Docket Number:	21-ESR-01
Project Title:	Energy System Reliability
TN #:	239934
Document Title:	SDG&E Comments on the Sept 23 Midterm Reliability Modeling Workshop
Description:	N/A
Filer:	System
Organization:	SDG&E
Submitter Role:	Public
Submission Date:	10/1/2021 2:03:56 PM
Docketed Date:	10/1/2021

SDG&E Comments on the Sept 23 Midterm Reliability Modeling Workshop

Subject: San Diego Gas & Electric Company Comments on the August 30, 2021, Midterm Reliability Analysis and Incremental Efficiency Improvements to Natural Gas Power Plants Workshop

What the ELCC and TF Mean for Capacity

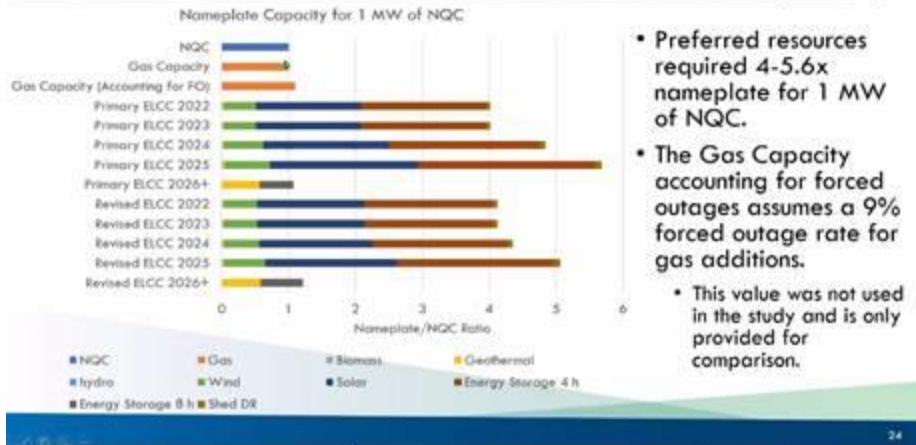
SDG&E appreciates the visual comparison, in Slide 24 below, of nameplate capacities and the additional statement that preferred resources require 4-5.6 times the name plate as compared to perfect capacity. The CEC analysis is useful as a stand-alone reliability study but without including costs and greenhouse gas (GHG) impacts it is of little use for planning purposes. As a practical matter, studying absolute scenarios, such as that *only* natural gas resources or preferred resources will be built, provides little value given that in order to achieve 2045 emission reductions and reliability goals at least cost it will likely be necessary to establish a portfolio mix of preferred resources (*e.g.*, renewables and energy storage resources) with dispatchable resources that provide critical reliability such as natural gas plants.
